**PROPOSED DEVELOPMENT: DANSON
ROAD, BEXLEYHEATH**

DESIGNER'S RESPONSE – STAGE 1 ROAD SAFETY AUDIT

**REPORT REFERENCE NO 190320-05
PROJECT NO. 190320
JANUARY 2021**

Road Safety Audit Stage 1

Drawing Title: **VISIBILITY & TRACKING PLAN**

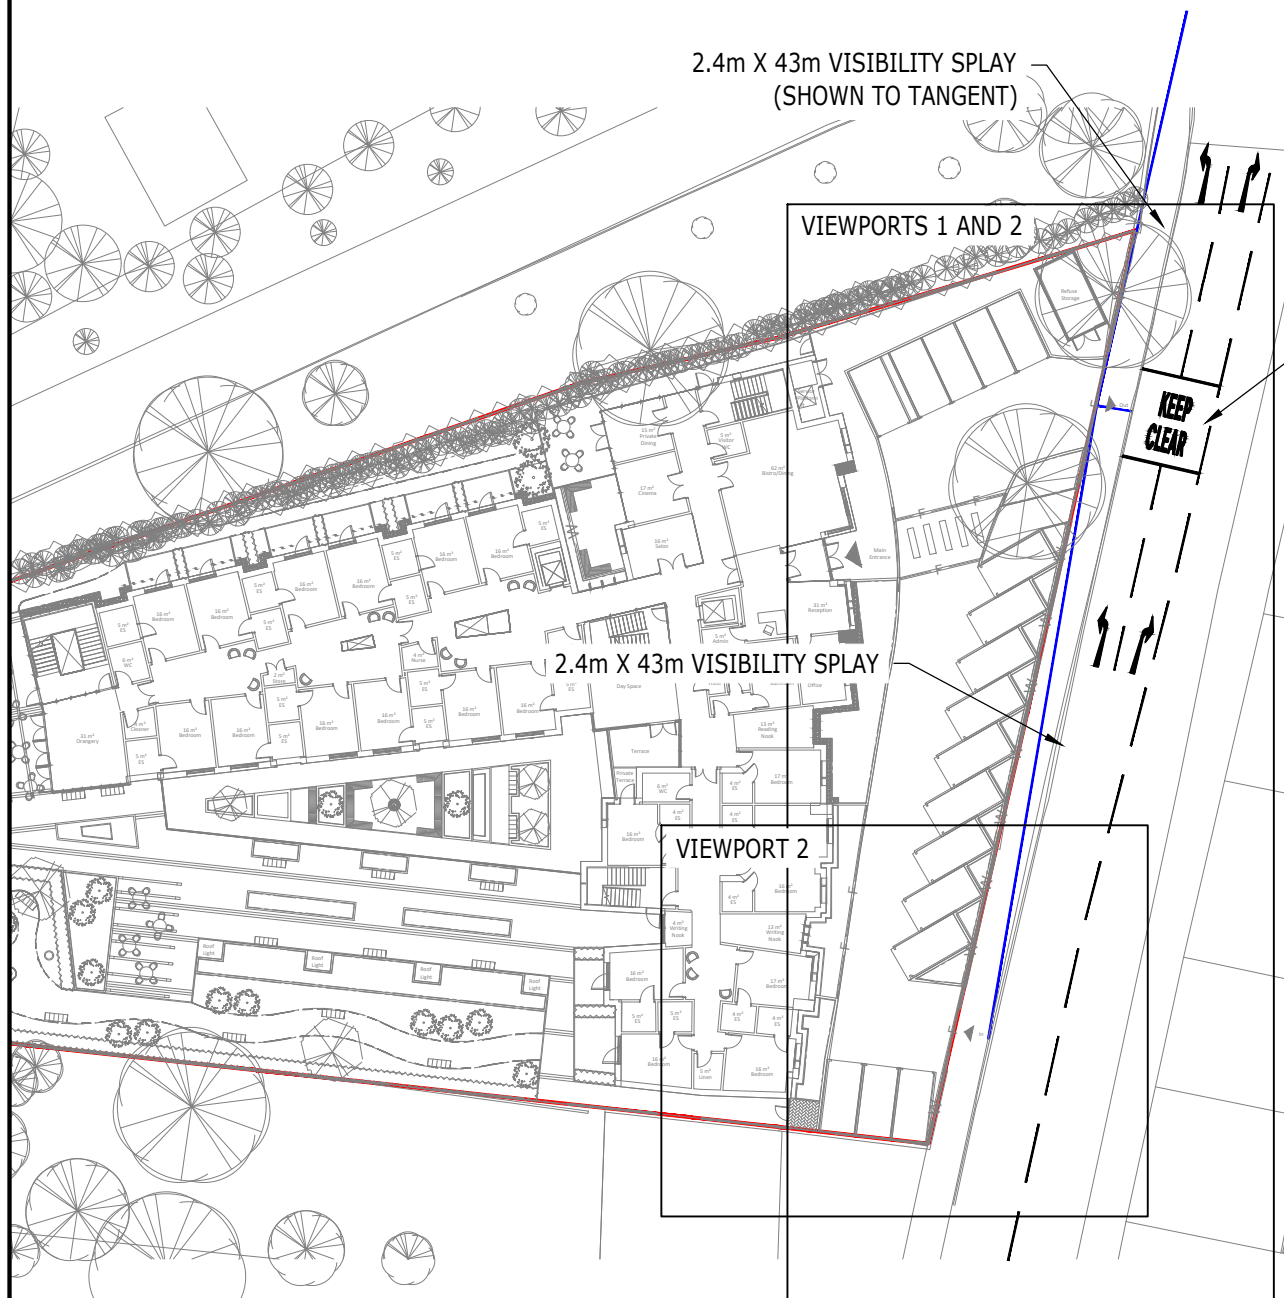
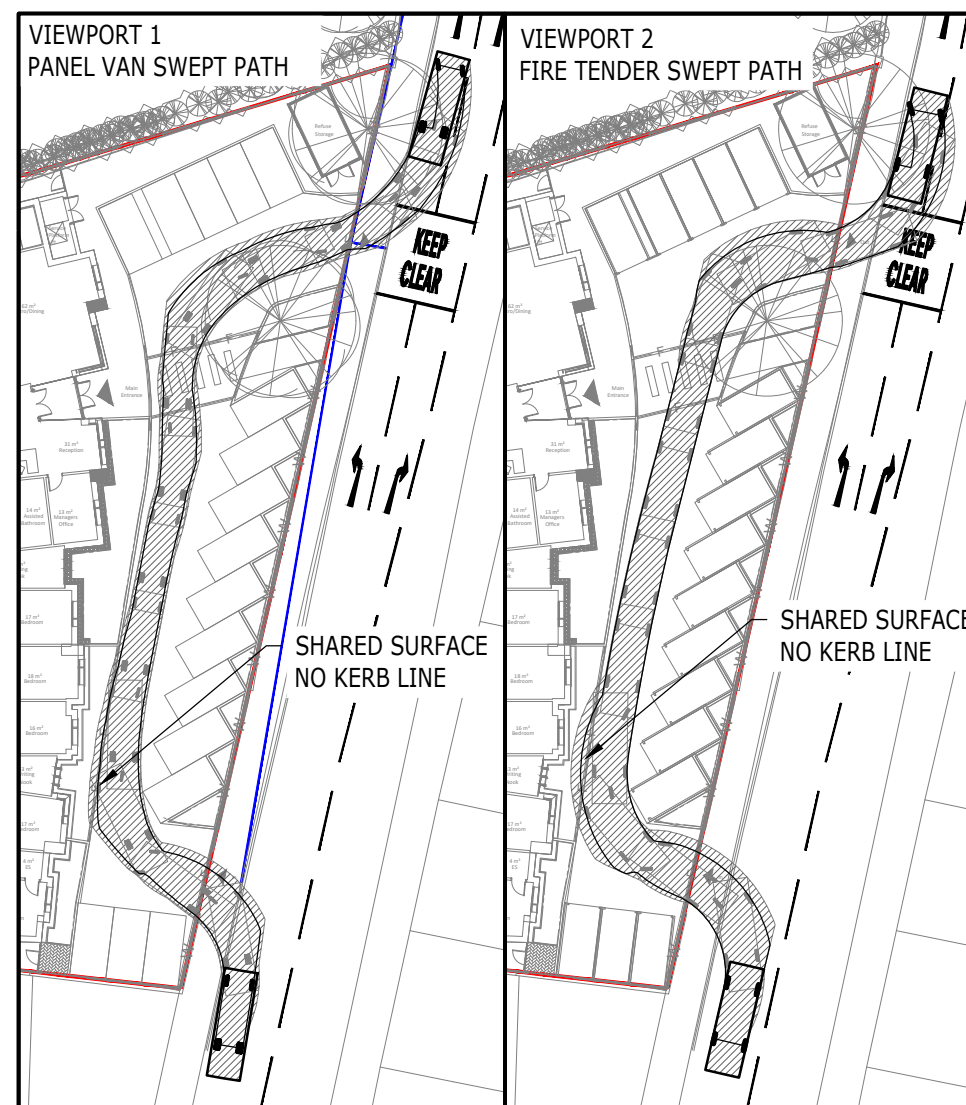
Problem	Agree / Disagree	Reason / Proposals
<p>3.</p> <p>3.1.1</p> <p>Insufficient gap acceptance could lead to side impact collisions.</p> <p>The proposed egress is located close to the signalised junction with Park View Road and Crook Log, where queueing was observed in the northbound lanes. It is likely that during peak periods traffic may have difficulty turning right when leaving the care facility. In peak periods, there is concern that traffic from the care facility may not have enough gap acceptance to undertake the right turn manoeuvre, which could lead to side impact collisions.</p> <p>RECOMMENDATION</p> <p>It is recommended that a Keep Clear marking, to diagram 1026, should be installed in the northbound lanes at the egress.</p>	<p>Agree</p>	<p>The recommendation to provide Keep Clear markings is accepted.</p> <p>Drawing 190320-001C has been revised to reflect the proposed road markings</p>

C	ROAD MARKINGS ADDED	AA	AT	IW	06.01.21
B	ADDED PANEL VAN TRACKING	BT	DV	IW	19.09.19
A	UPDATED TO LATEST LAYOUT	BT	DV	IW	06.09.19
Rev	Description	Drn	Chk	App	Date

Plan attached showing the locations of the problems identified as part of this audit (location numbers refer to paragraph numbers in the report).

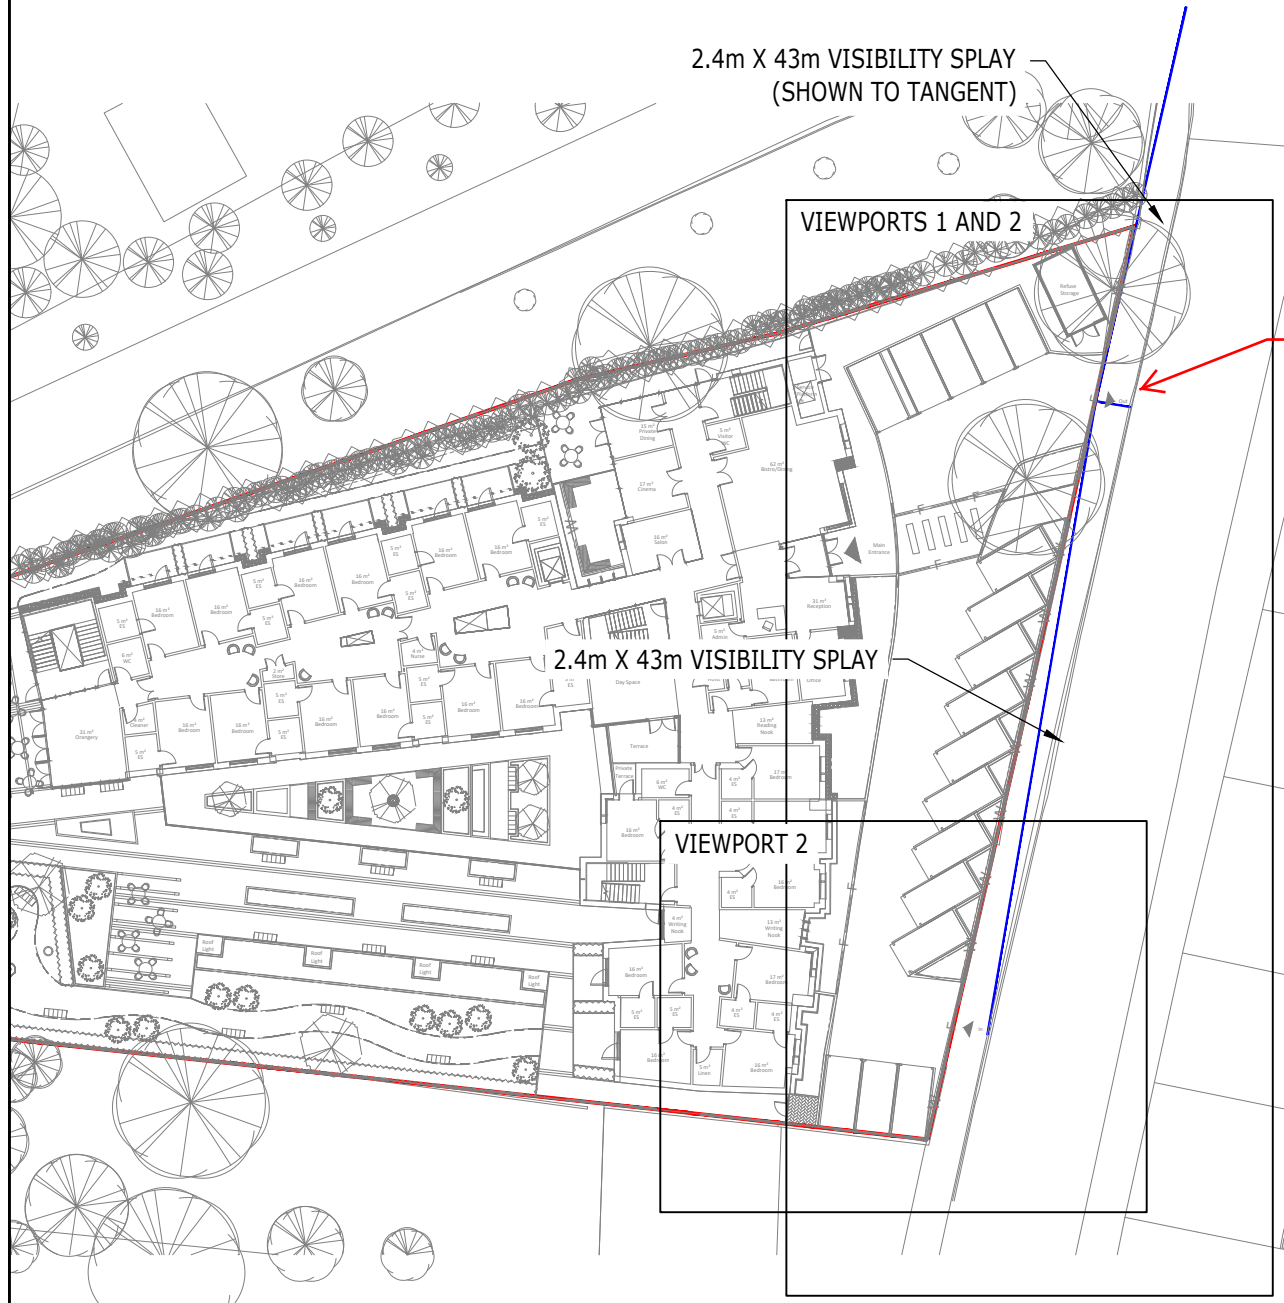
3.3.1 PROBLEM

Location: Proposed egress.

Summary: Insufficient gap acceptance could lead to side impact collisions.

The proposed egress is located closed to the signalised junction with Park View Road and Crook Log, where queueing was observed in the northbound lanes. It is likely that during peak periods traffic may have difficulty turning right when leaving the care facility. In peak periods, there is concern that traffic from the care facility may not have enough gap acceptance to undertake the right turn manoeuvre, which could lead to side impact collisions.

RECOMMENDATION

It is recommended that a Keep Clear marking, to diagram 1026, should be installed in the northbound lanes at the egress.
